**Re: Spring Creek North Continuation Project Information Request Response**

This letter has been prepared to address the Departments request for information (RFI) to assess the application to amend environmental authority EPML00370013 (application reference A-EA-AMD-100430427), issued to Rolleston Coal Holdings Pty Ltd (RCH) on 19th July 2023.

**Table 1** of this letter contains the RFI as provided by the Department, and the relevant response from RCH, incorporating information and advice from technical specialists. Section 2 contains additional supporting information, referenced within the **Table 1** responses.

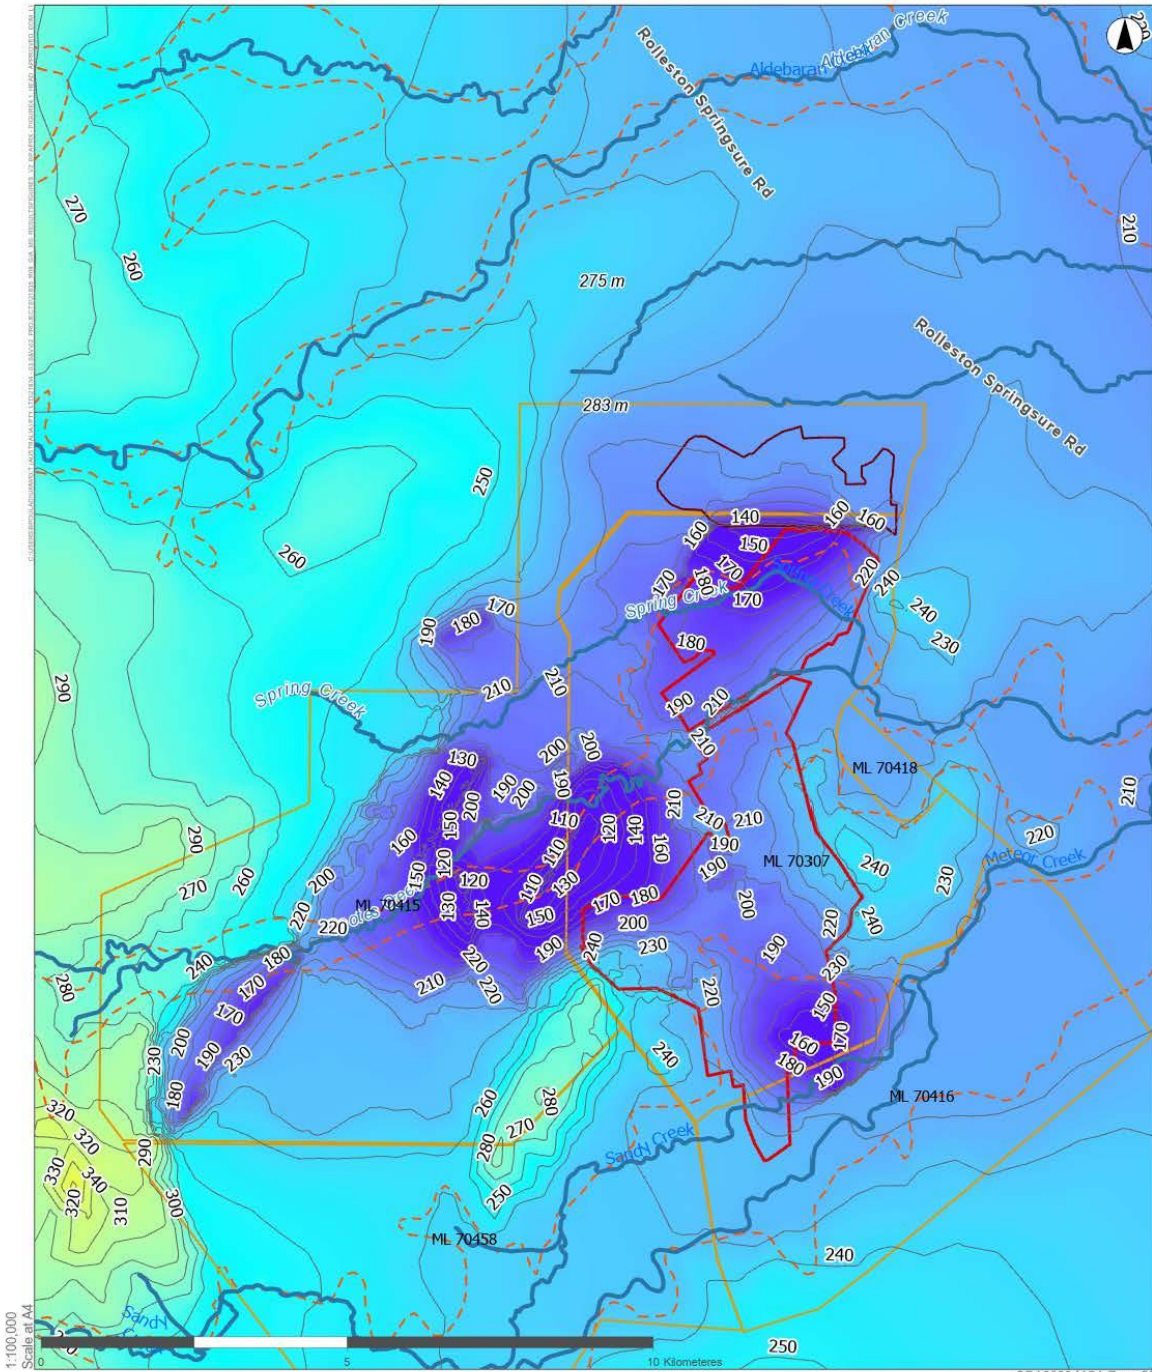
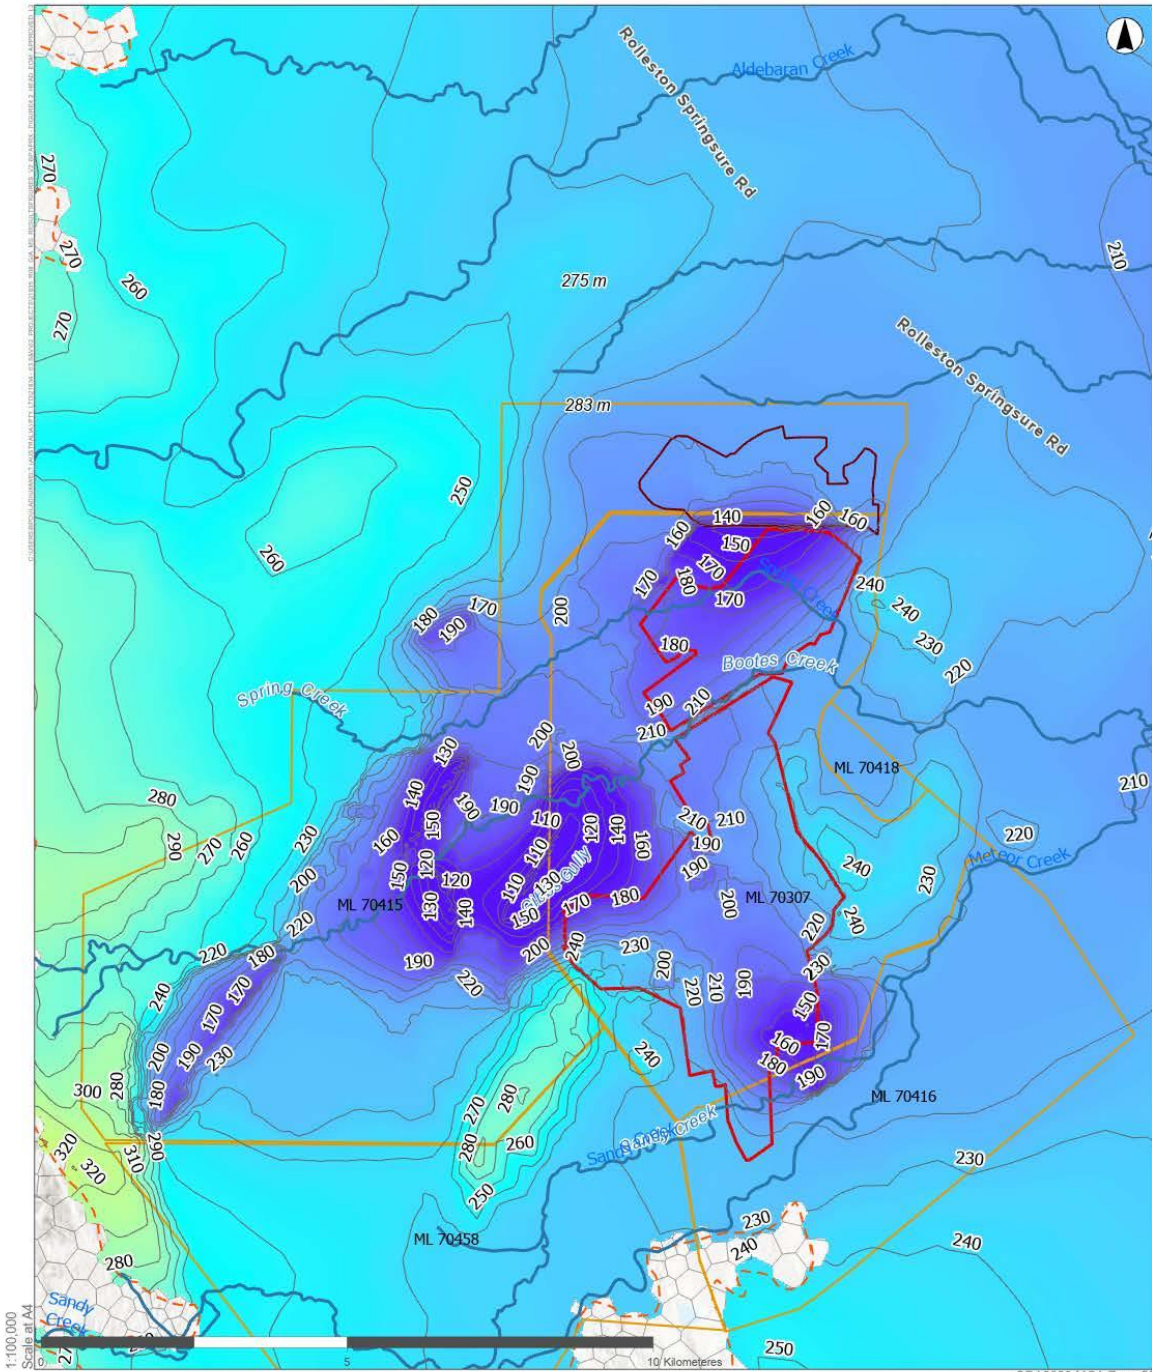
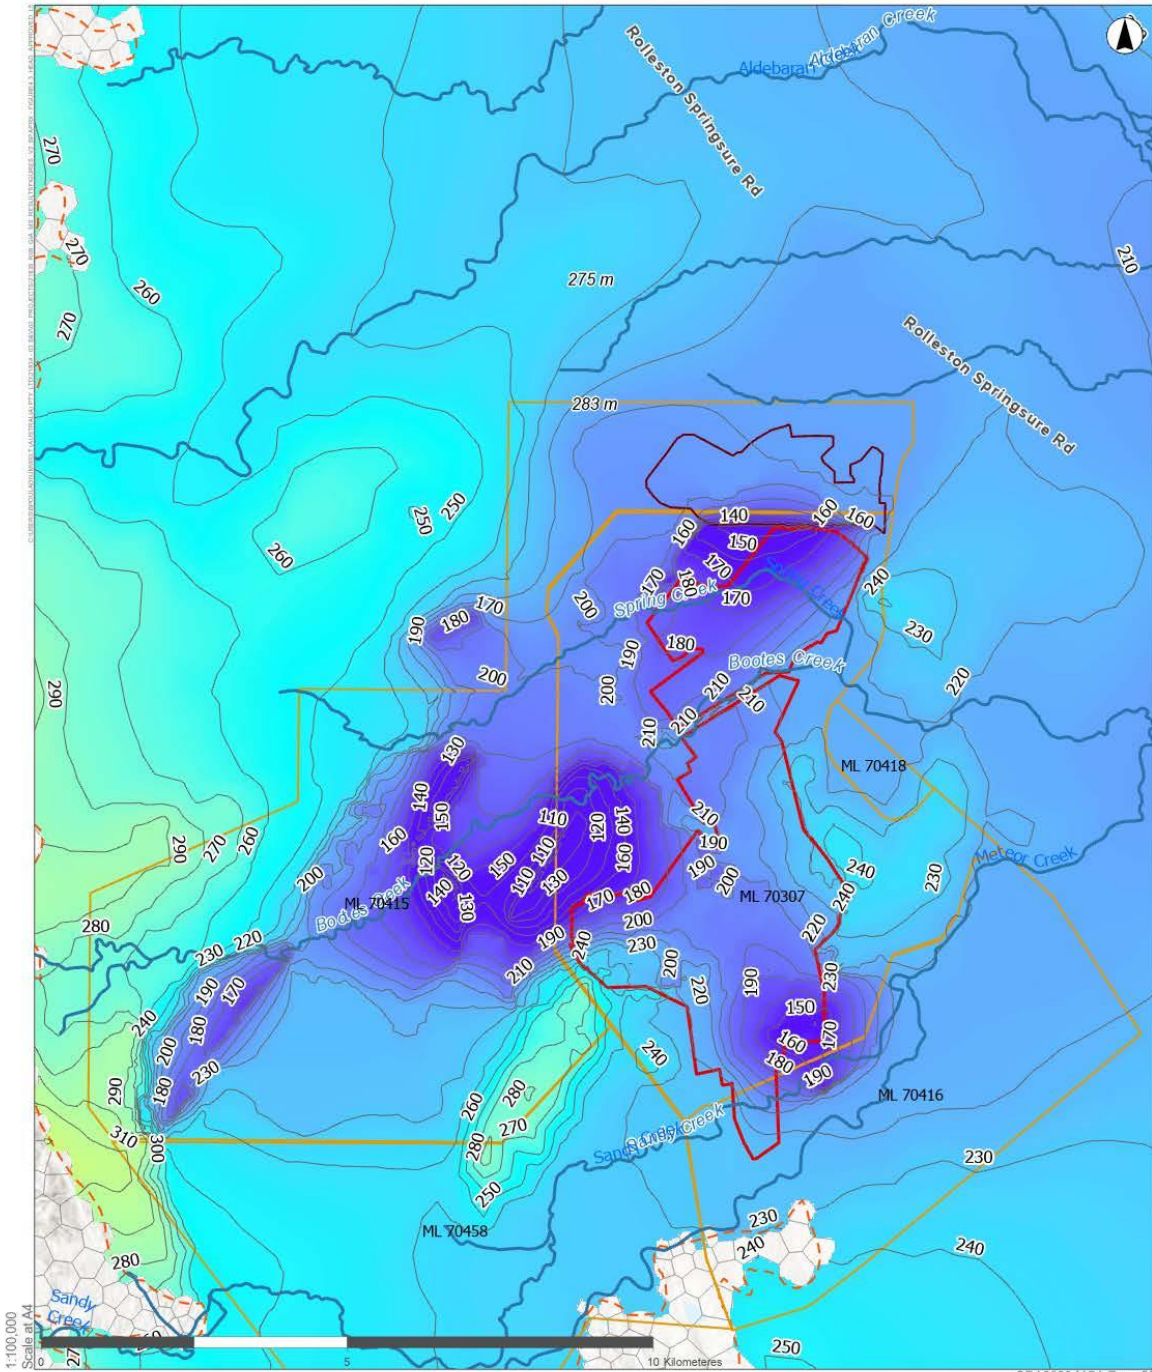
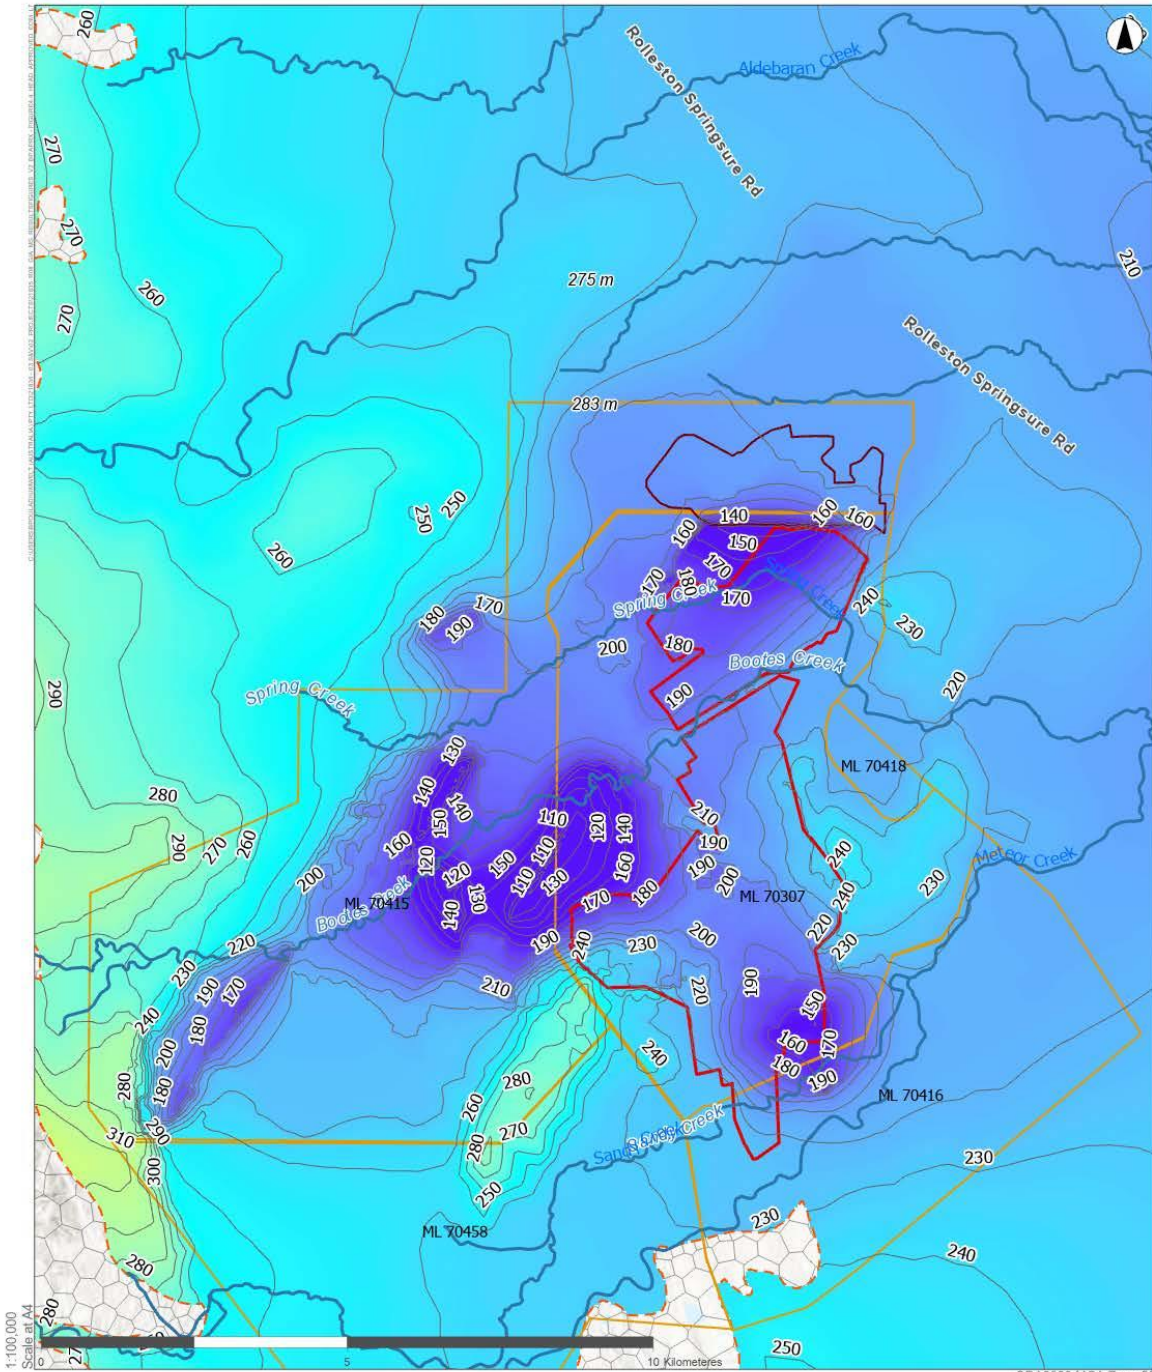
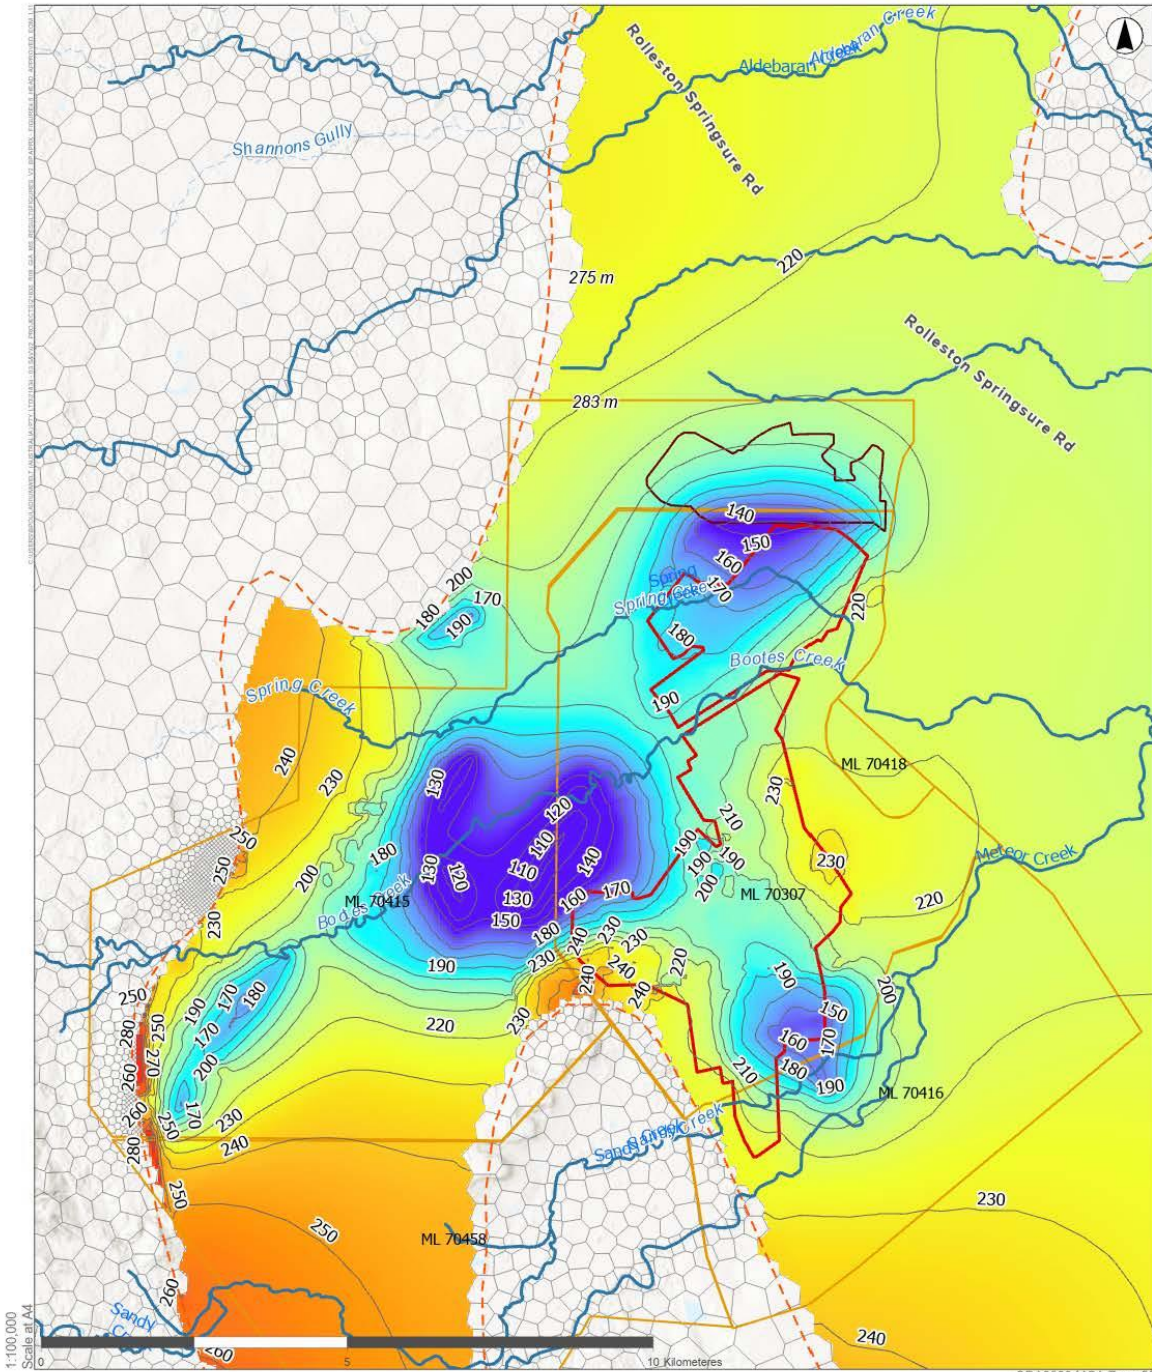
<p><b>11</b></p>	<p><b>Groundwater - Elevation Contours</b></p> <p>Appendix B Figures 4.1 to 4.10 provide predicted water level elevations in various layers at the end of mining, are presented at 50 m contour intervals and at a scale difficult to interpret around the mine and void areas.</p>	<p>Provide more detailed maps to allow the department to better understand the predicted groundwater level elevations at the end of mining.</p>	<p>Updated maps with greater resolution are presented in Section 2.7.</p>

Modelled groundwater levels at the end of the mining are represented in Figure 4.1 to Figure 4.5 below. This is based on the ‘Approved’ mine plan that represents the original mine plan modelled by AGE (2014) and approved operations at MDS, and extracted for Alluvium-Regolith (Layer 2) Tertiary Basalt (Layer 5) and D seam (Layer 11).

Modelled groundwater levels at the end of the mining for the Project are represented in Figure 4.6 to Figure 4.10 below, for Alluvium-Regolith (Layer 2) Tertiary Basalt (Layer 5) and D seam (Layer 11). The graphs have been updated to 1:100,000 mapping and include 10 m contours for the predicted groundwater head.
